Office Action Summary	Application No. 10/591,341	Applicant(s) OREN ET AL.	
	Examiner MARK MASHACK	Art Unit 3773

2. **Claims 1-8** rejected under 35 U.S.C. 102(b) as being anticipated by **Furusawa (US 2001/0041901)**.

Fig. 19C***Claim Rejections - 35 USC § 103***

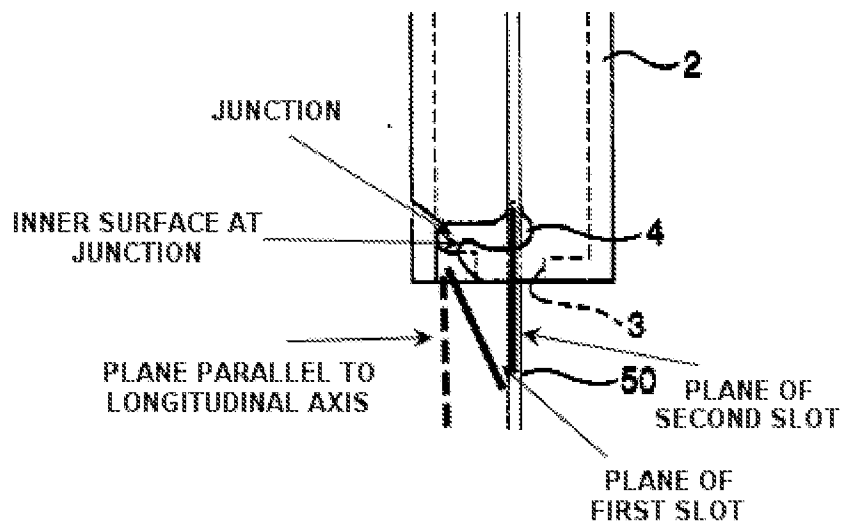
Furusawa discloses an implement for manipulating a knotted suture comprising:
an elongated shaft **2** having a proximal end and a distal end engageable with a knotted suture (FIG 19);

a distal end with a recess **3** for receiving the knot of the suture;

said distal end has an open slot **4, 5** with a first section leading from said recess towards the proximal end and a second section leading from a juncture with said first section towards the distal end but terminating short of the end face. Said first slot section is a three dimensional object and hence has an infinite amount of plane, one of which is in a plane at an angle of 10-30 degrees relative to the longitudinal axis. Said second slot section additionally comprises a plane parrallel to the longitudinal axis of the elongated shaft (FIG 19C). The second slot section can be considered leading towards the distal end but terminating short since it widens towards the distal end after the inner surface of the junction. One segment of the plane of said second slot section is rotated

approximately 90 degrees with respect to one segment of the plane of said first slot section (FIG 19A). The slots decrease from said juncture toward the distal since the rounded inner surface of the junction juts out into the slots.
